DATE Dec. 1981
NUMBER 90-23-A

SERVICE BULLETIN

INDEX PREVENTIVE MAINTENANCE (REVISED)

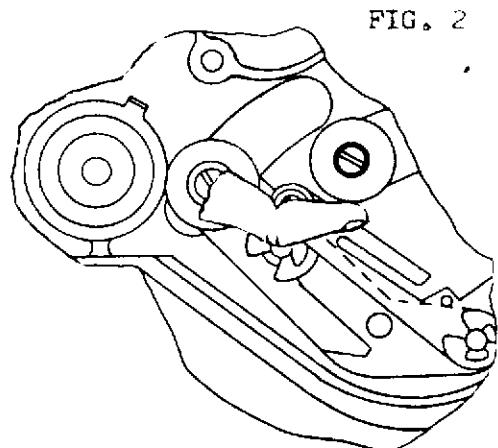
PROBLEM: Improper operation of Gate Lever will not set the required loops causing projector to shut off upon turning the Control Knob.

REMEDY: Raise Gate Lever to full open position. Lower Gate Lever slowly until rear shoe closes. Check lower loop setter to see if it can be released very easily by lifting it with finger. (Refer to Fig. 2). It should be firmly in position. If it releases by applying a slight pressure, press lever (A) Fig. 3 in towards casting slightly so that lever will be seated properly on catch (B). Continue to lower Gate Lever slowly until lower loop releases then press on top loop setter to be sure it is securely seated.

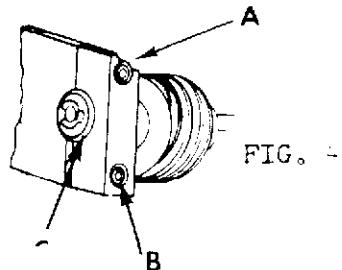
PROBLEM: Loose bearing will cause excessive shuttle protrusion.

REMEDY: Tighten top screw (A) securely. Tighten screw (B) just tight enough so that the bearing will not move. Do not overtighten. The best method to check this is to insert shuttle adjustment wrench at point (C), and with excessive pressure the bearing should not move. If it does, tighten Screw (B) until the bearing doesn't move. (Refer to Fig. 4)

FIG. 5

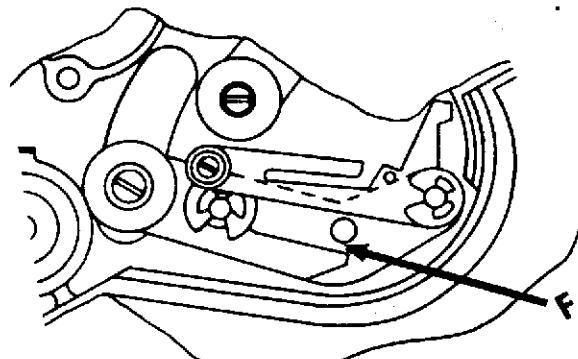
D. Check Pinch Roll pressure.
PROBLEM: Garbled sound.

1. Rotate Control Knob to Forward operating position. There should be approximately 1/8" clearance between Pinch Roller Arm Assembly and stud on Pinch Roller Actuating arm. (Refer to Fig. 5)
2. If you do not have this clearance, perform the following:
 - A) If serial number of projector is below 920-6587, replace Cam Bearing Assembly behind Control Knob. (Refer to Fig. 6)
 - B) To adjust, loosen screw (A) Fig. 7. Rotate eccentric (B) counterclockwise approximately 1/4 turn. Secure screw (A).
 - C) Control Knob may be loose. Tighten. There should be a slight amount of forward motion of Control Knob after knob is in Forward position. If not, remove knob and file about 1/4 off of extrusion on knob. (Refer to Fig. 8)

FIG. 9

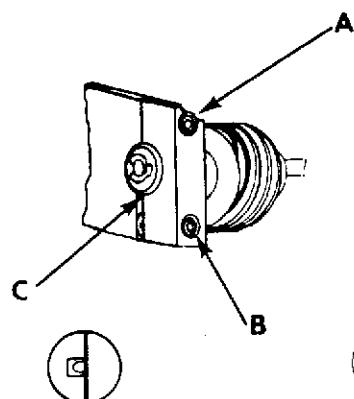
PROBLEM: Excessive or insufficient shuttle protrusion will cause continual revolving of lower loop setter.

1. Loosen set screws (A) and (B) Fig. 9.
2. Rotate hex end of bearing at point (C) clockwise to decrease protrusion; counterclockwise to increase protrusion. (Use shuttle wrench 53529)

FIG. 12

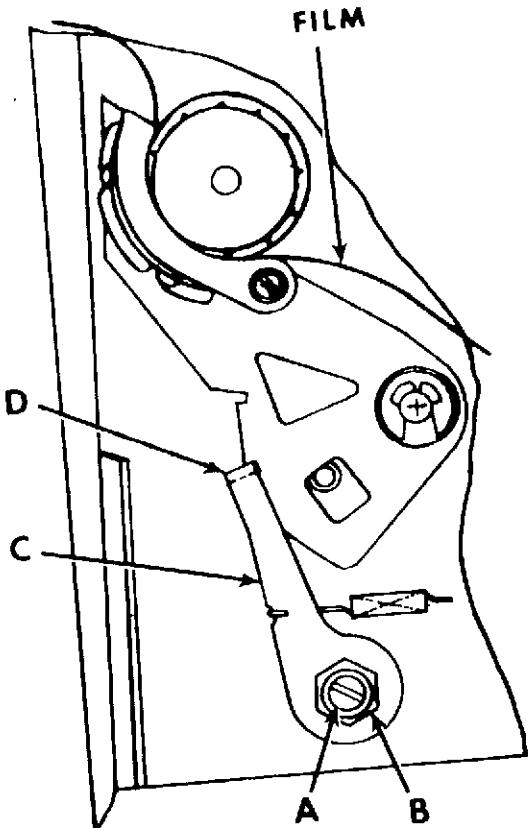
PROBLEM: Film slipping through Rear Shoe causing Top Loop Setter Switch to activate turning off projector.

1. Thread projector and close gate.
2. Loosen screw (A).
3. Rotate eccentric (B) clockwise which will raise latching lever (C).
4. Latching lever (C) should just touch top on notch on shoe bracket at point (D) and then tighten screw (A) securely.
5. Raise Gate Lever to full open position.
6. Rotate Control Knob to Forward position and while projector is running film, manually move latch lever to left and then release. It should just clear top of notch at point (D) without binding.

FIG. 16

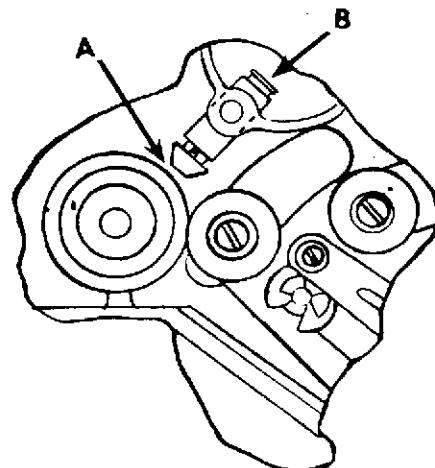
PROBLEM: Muffled sound. Low volume.

REMEDY: Remove foreign material from Sound Lens using a pipe cleaner dipped in alcohol. Insert the pipe cleaner between the Sound Drum and the Sound Lens at Point A. Clean the glass disc covering the top of the Sound Lens, Point B.

FIG. 17

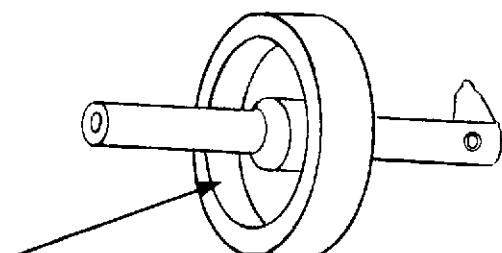
PROBLEM: Excessive tork on take-up.

REMEDY: Remove spindle from Take-up Arm. Apply special lubrication S111-13 on cork. Refer to Fig. 17. (note: we began using this new lubrication on projector serial No. 921-4358)

FIG. 19

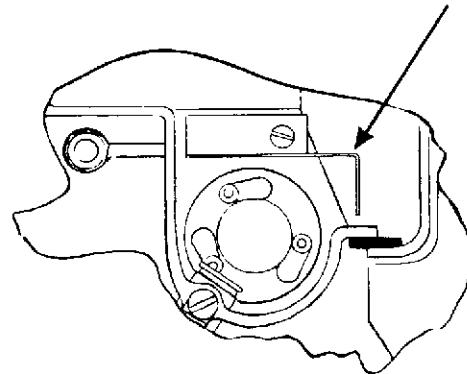
PROBLEM: Incorrect exciter lamp causing low volume.

REMEDY: Place on the exciter lamp shield the self-adhesive sticker #53925. Refer to Figs. 18 & 19.

FIG. 20

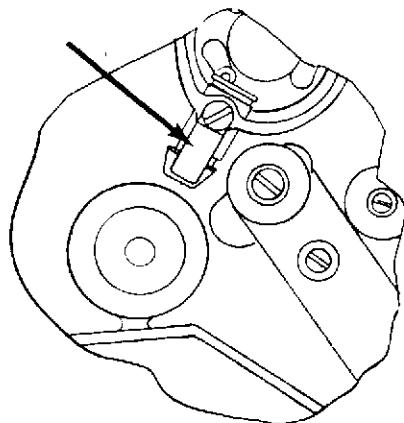
PROBLEM: Film lays against sound lens causing no sound.

REMEDY: Install Film Guide #53924 using screw #S254-832-3. Refer to Fig. 20. (note: we began installing this film guide with projector serial No. 921-3819)
